City Commission  
June 3, 2008

# Gables Waterway

# Planning Department recommendation

The Planning Department based upon the complete findings of fact contained within the Staff report recommends denial of the five (5) applications referred to as “Gables Waterway”  
(pg 2)

## 2. Incompatible transition of massing (pgs 15-18)

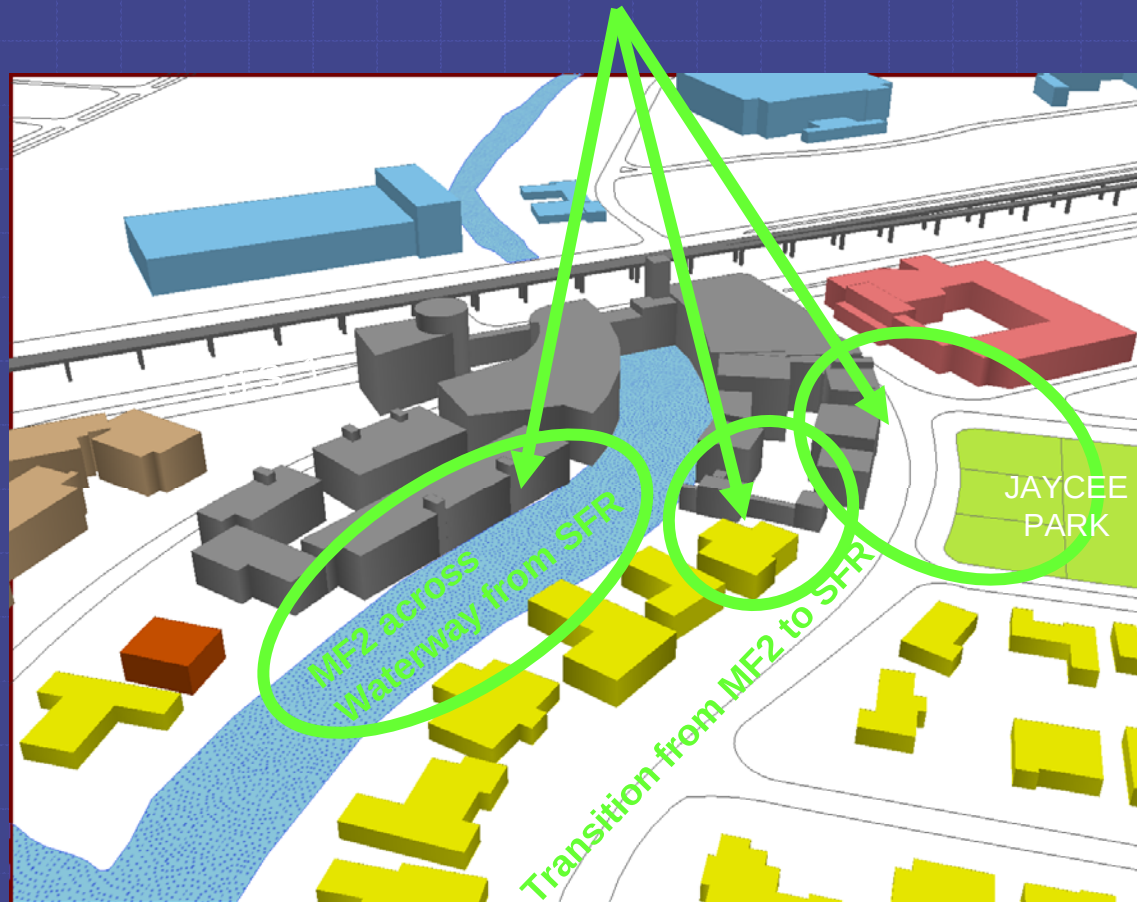
- Project does not provide adequate **transition of massing**
- Project does not provide adequate transition in **height and scale** from U.S.1 back to the existing single-family and duplex uses
- 5 story height of residential building across from **Jaycee Park**, and proposed reduction of both the required **front and rear setback** of the project's multi-family residential structures would impact adjoining properties and single-family residences located across the canal

## Comparison of Allowed/Existing and Proposed Development

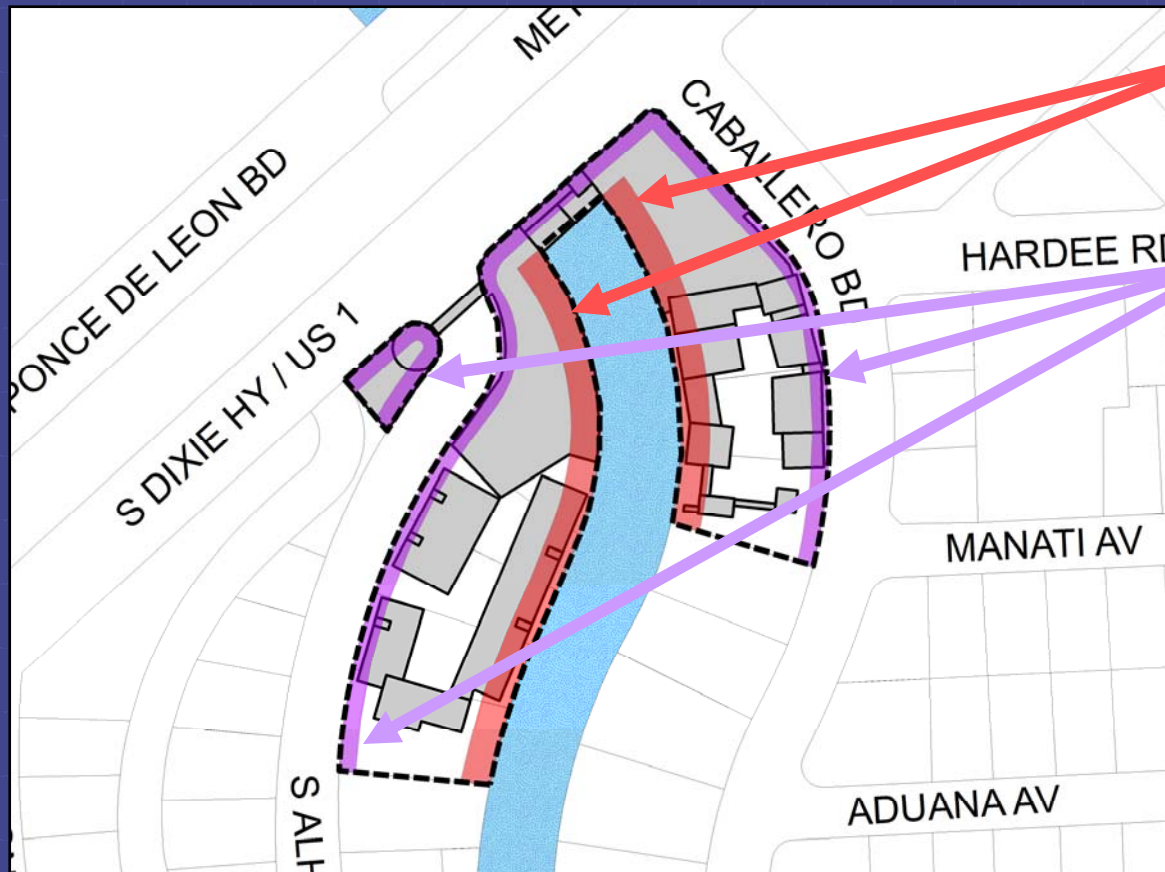
- Project's size and density are **inconsistent with scale and character** of the surrounding neighborhood
- Applicant's proposed mitigation **does not support the award of requested site development bonuses**
- Proposed project with bonuses (setback relief, building height and additional residential units) results in increased project size, loss of open space and existing tree canopy, and insufficient transition and buffering between uses which are **inconsistent with the scale and character of the surrounding neighborhood**
- Would **encourage further incompatible redevelopment**
- Preliminary Zoning Analysis indicates the 20% on-site landscape open space required for a PAD has not been met and the **applicant requires credit for off-site landscaping**

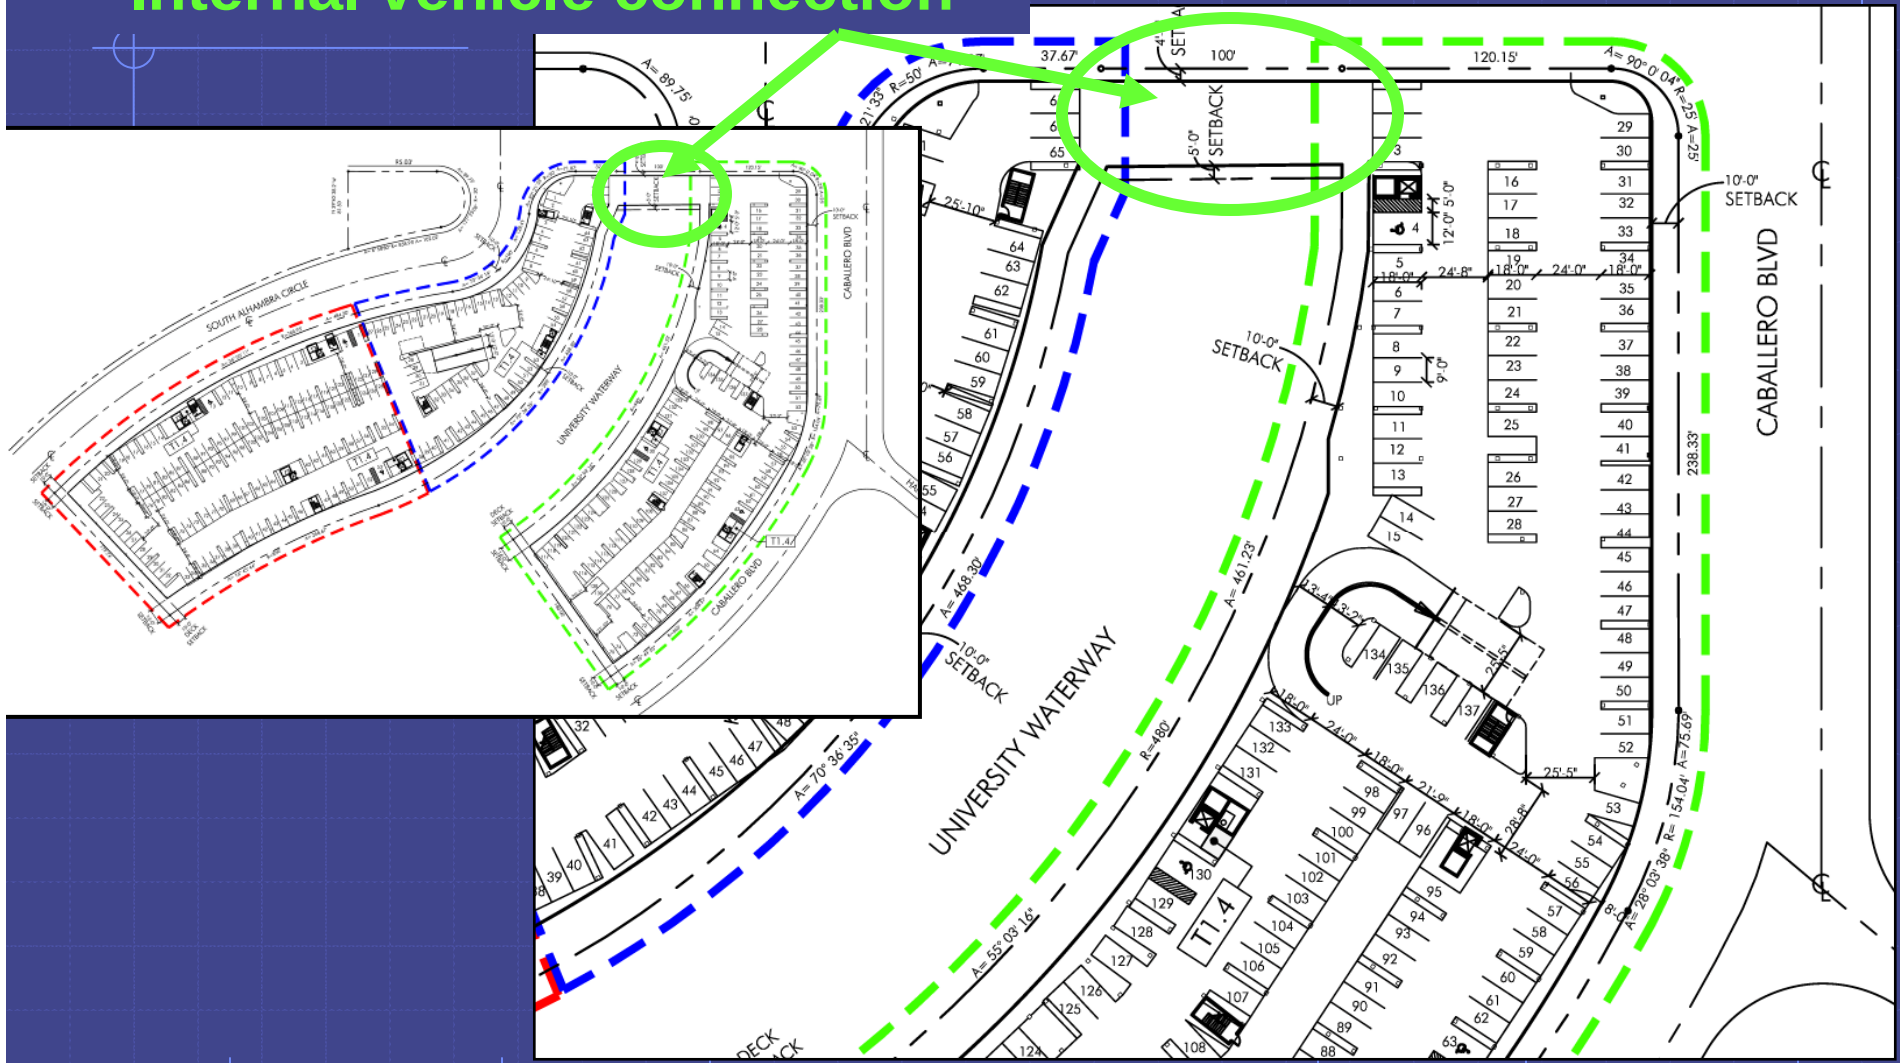
4. **Potential off-site parking encroachment (pgs 21-23)**
- Parking generated by the project could **encroach into the surrounding neighborhood** if left unmanaged
  - **No overflow parking management plan**, including short term meters, residential parking permits, directional signage and enforcement measures is provided to ensure that parking does not spill over into the surrounding residential neighborhood.
  - No plans provided for the proposed **vehicle connection** between the underground parking areas that would allow and encourage on-site vehicular circulation

## 6. Project phasing (pgs 26-32)

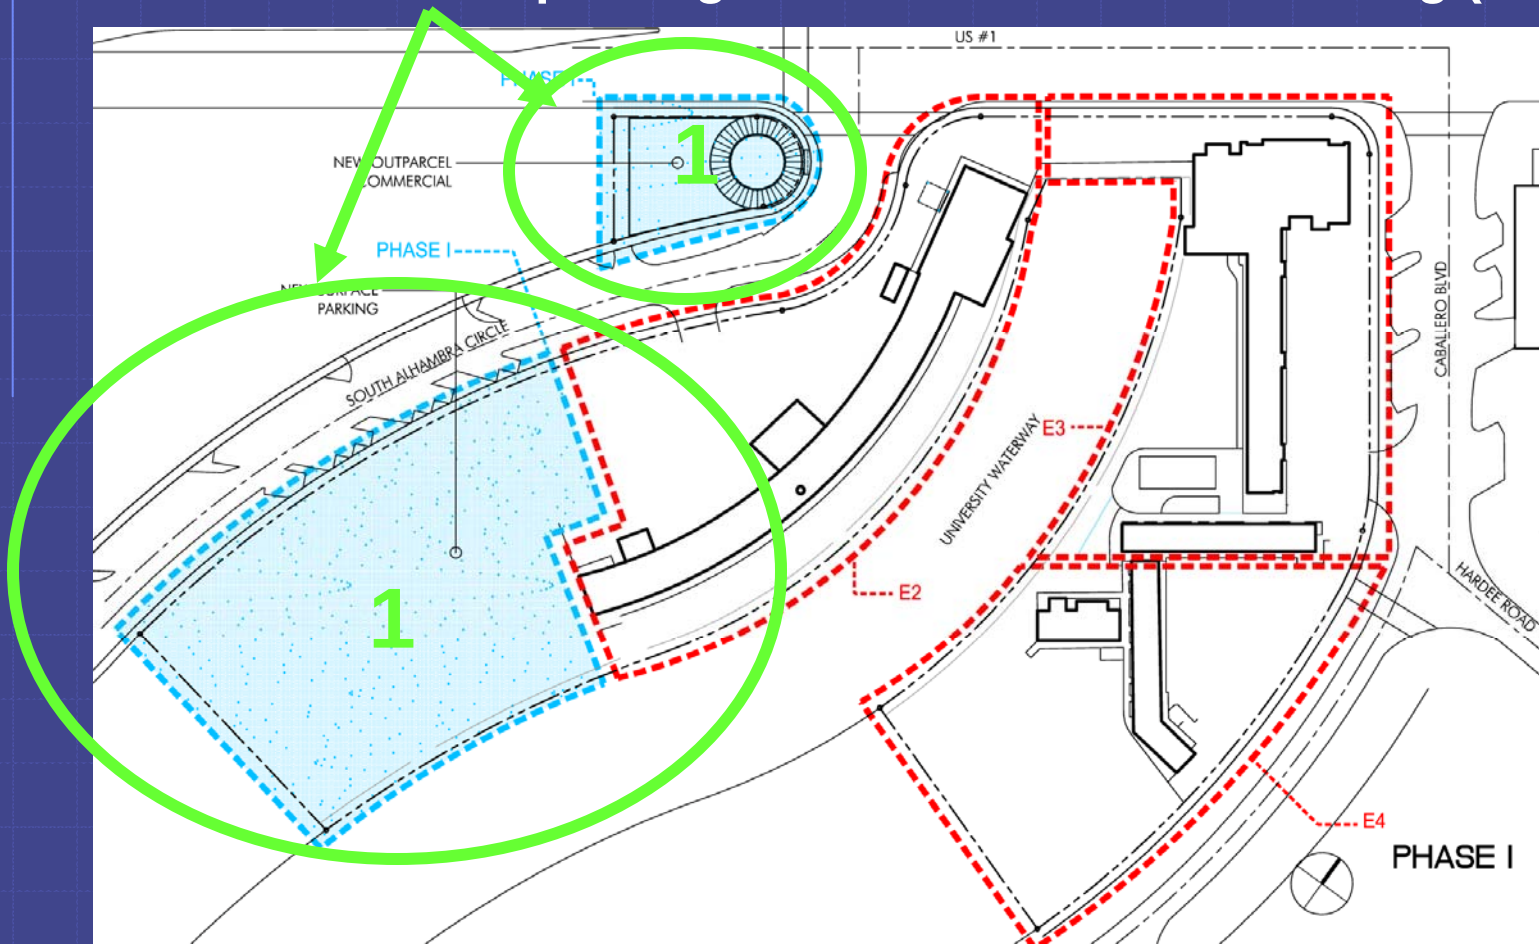
- Project is proposed to be developed in various phases, which if left unplanned and/or unchecked, could result in significant **impacts to the surrounding neighborhood**
- **No assurances provided** that the project fulfills the PAD objectives and purpose if the project is not built-out and all proposed phases constructed
- A **projected timeline is necessary** for each phase of the project and for the build-out of the entire project
- No proposed use of **proposed interim surface parking lot** or plan has been submitted providing details showing vehicular entrances, paving/curbing, landscaping, lighting and pedestrian circulation

## Lack of marina facilities operation plan

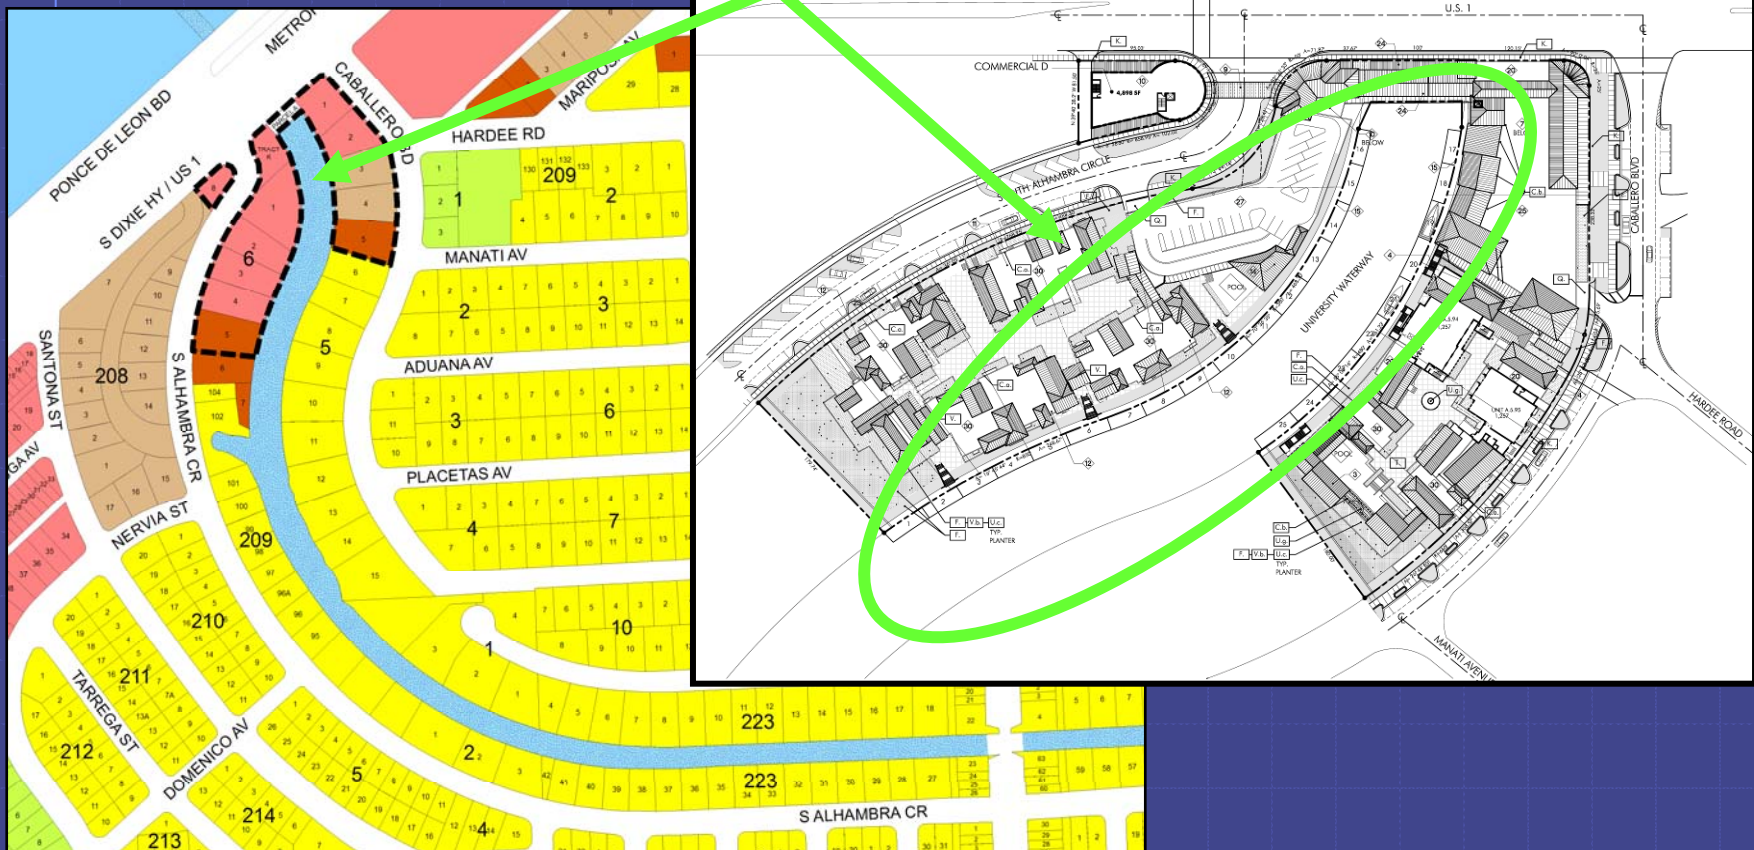
- Project will result in **increased use of existing marina** situated along **ecologically sensitive canal habitat**, which, if left unmanaged, could negatively impact the canal and surrounding single-family residential neighborhood
- **No operational plan provided** for the renovation and use of the existing 25 boat berths that are proposed to be assigned to owners of new residential units
- Marina is located at the end of a canal utilized primarily by the existing single-family residential neighborhood through which the canal courses, and serves as an environmentally sensitive manatee habitat
- Application **does not sufficiently address the servicing of vessels** at the marina to ensure there is minimal impact on the surrounding residential neighborhood and existing manatee habitat along the waterway
